APP-GW-GLR-079-NS, Revision 2

"AP1000 Verification of Water Sources for Long-Term Recirculation Cooling Following a LOCA"

Technical Report Number 26  
(Redacted Version)

**TITLE: AP1000 Verification of Water Sources for Long-Term Recirculation Cooling Following a LOCA**

**Table 2.2.3-4 (cont.)  
Inspections, Tests, Analyses, and Acceptance Criteria**

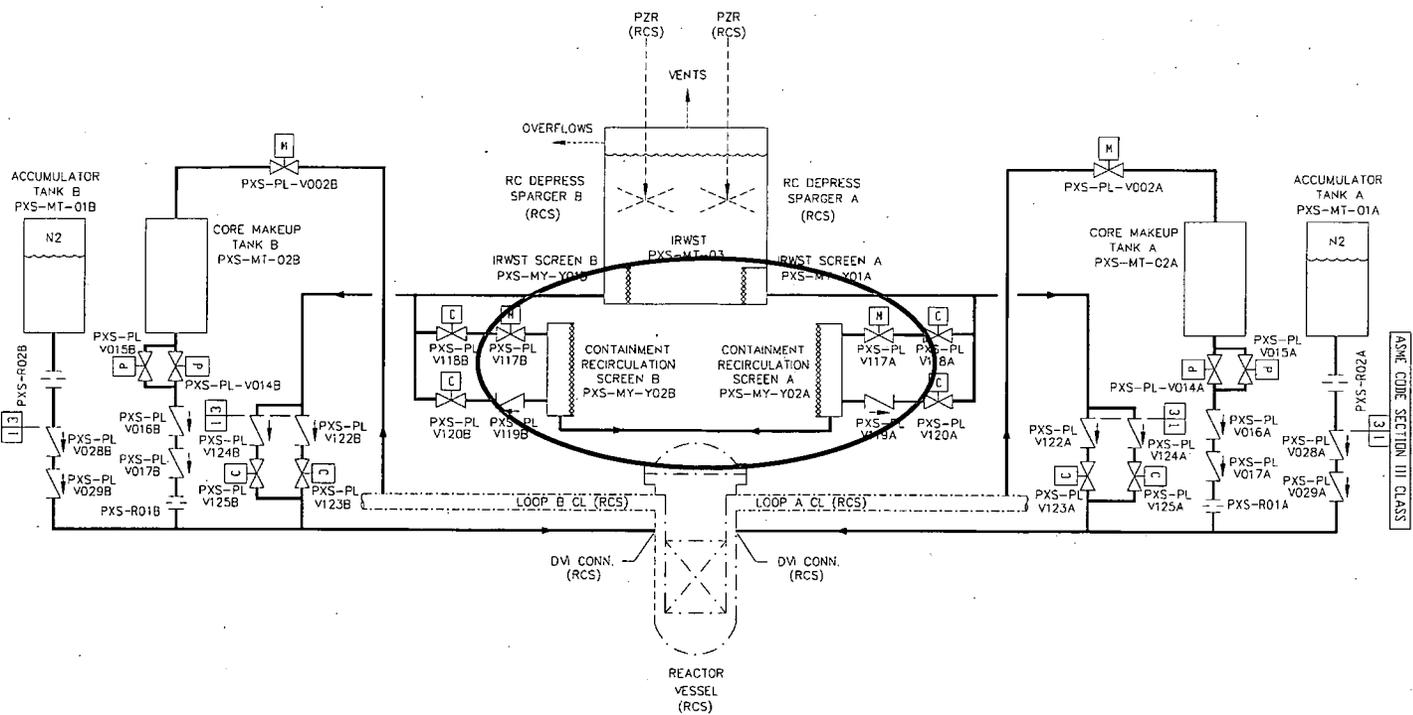
Design Commitment	Inspections, Tests, Analyses	Acceptance Criteria
	<p>vii) Inspection of the as-built components will be conducted for plates located above the containment recirculation screens.</p> <p>viii) Inspections of the IRWST and containment recirculation screens will be conducted.</p> <p>ix) Inspections will be conducted of the insulation used inside the containment on ASME Class 1 lines and on the reactor vessel, reactor coolant pumps, pressurizer and steam generators.</p> <p>x) Inspections will be conducted of the as-built nonsafety-related coatings or of plant records of the nonsafety-related coatings used inside containment on walls, floors, ceilings, structural steel which is part of the building structure and on the polar crane.</p> <p>xi) Inspection of the as-built CMT inlet diffuser will be conducted.</p> <p>xii) Inspections will be conducted of the CMT level sensors (PSX-11A/B/D/C, - 12A/B/C/D, - 13A/B/C/D, - 14A/B/C/D) upper level tap lines.</p>	<p>vii) Plates located above each containment recirculation screen are no more than 1 ft above the top of the screen and extend out at least 10 ft perpendicular to and at least 7 ft to the side of <del>the trash rack portion of</del> the screen <u>surface</u>.</p> <p>viii) The screen surface area (<del>width x height</del>) of each screen trash rack is <del>≥ 70 ft<sup>2</sup> and</del> of each <del>fine</del> IRWST screen is <del>≥ 500 ft<sup>2</sup></del> <u>140 (unfolded area)</u>. <u>The screen surface area of each containment recirculation screen is ≥ 2500 ft<sup>2</sup></u>. The bottom of the containment recirculation screens is ≥ 2 ft above the loop compartment floor.</p> <p>ix) The type of insulation used on these lines and equipment is a metal reflective type or a suitable equivalent.</p> <p>x) A report exists and concludes that the coatings used on these surfaces has a dry film density of ≥ 100 lb/ft<sup>3</sup>.</p> <p>xi) The CMT inlet diffuser has a flow area ≥ 165 in<sup>2</sup>.</p> <p>xii) The centerline of each upper level tap line at the tee for each level sensor is located 1" ± 1" below the centerline of the upper level tap connection to the CMT.</p>

DCD Figure 2.2.3-1 (Sheet 2 of 2)  
 Passive Core Cooling System

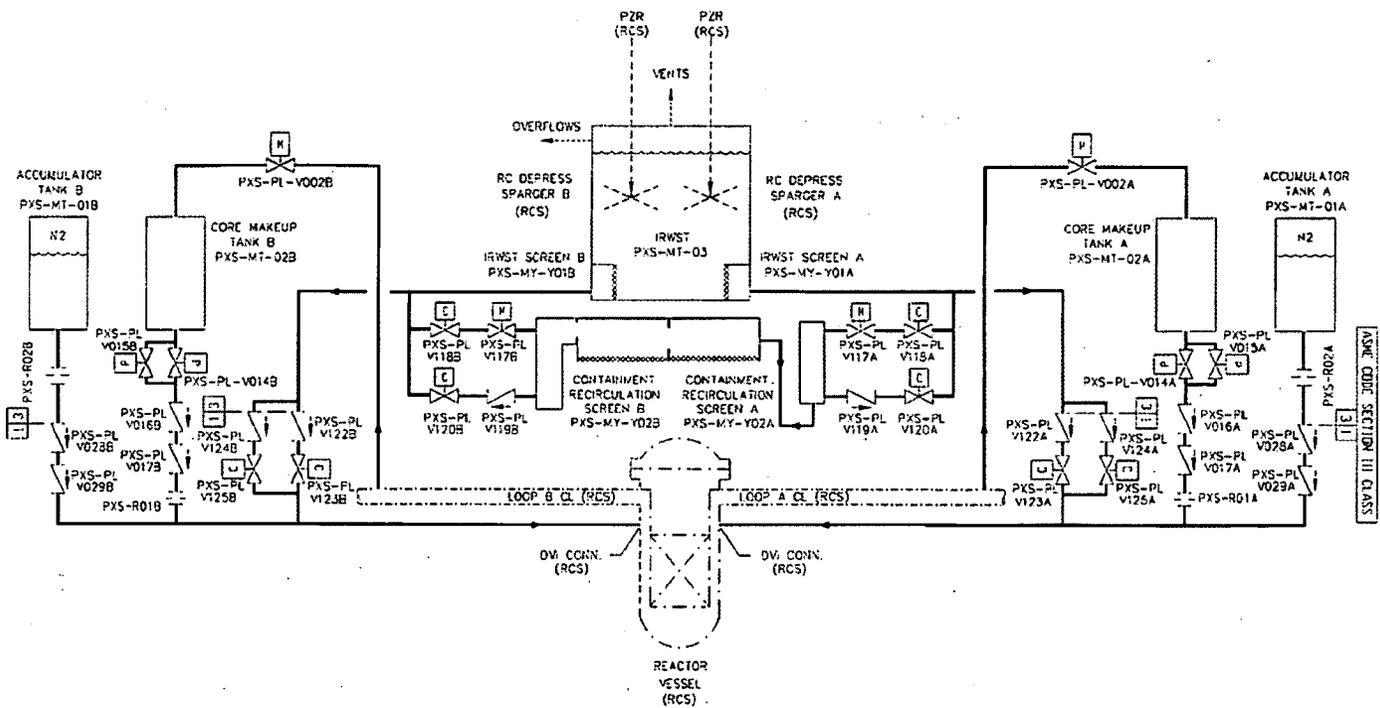
Current DCD Figure Showing Area to be Revised

Revised DCD Figure

Figure 3E-4 (Sheet 2 of 2)  
High Energy Piping – Passive Core Cooling System

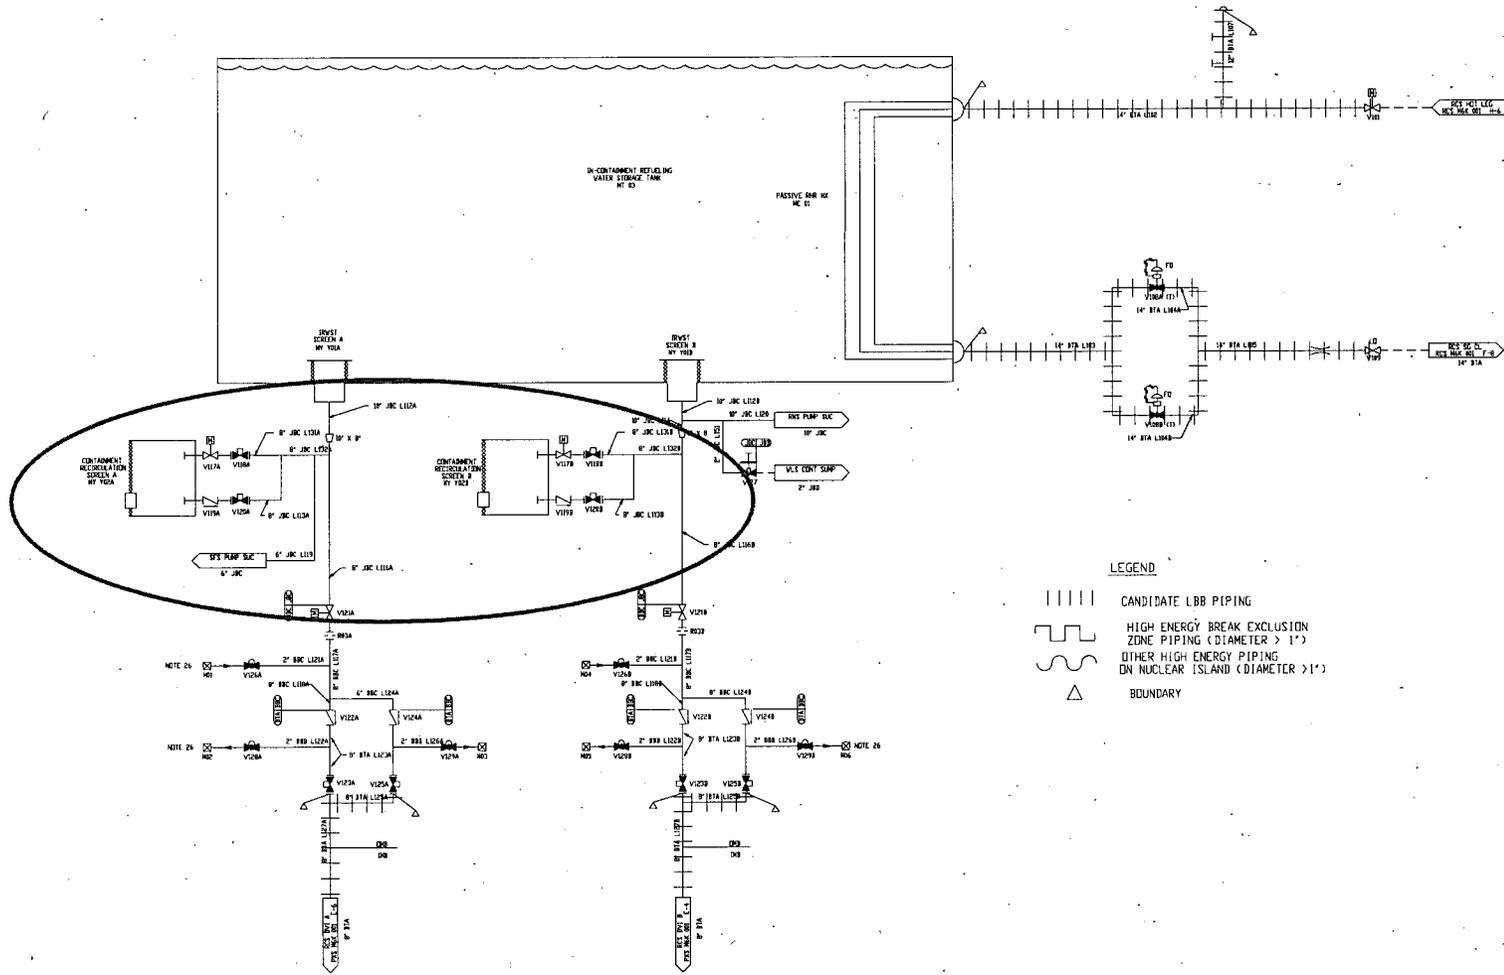
Revised DCD Figure

Inside Reactor Containment  
Figure 6.3-3

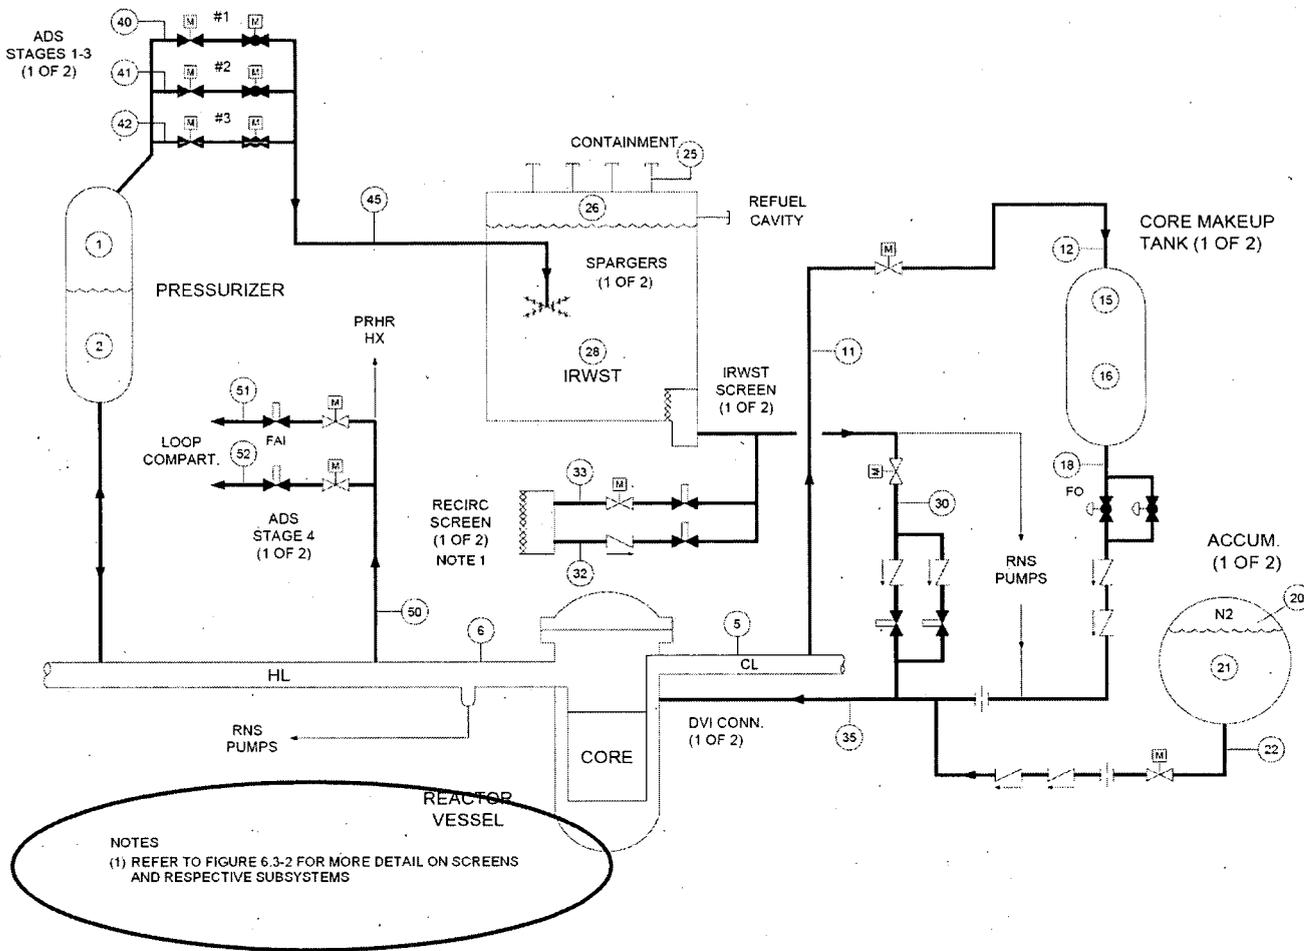
Modifications in indicated area same as modifications to Figure 6.3-2

Revised DCD Figure with addition circled.
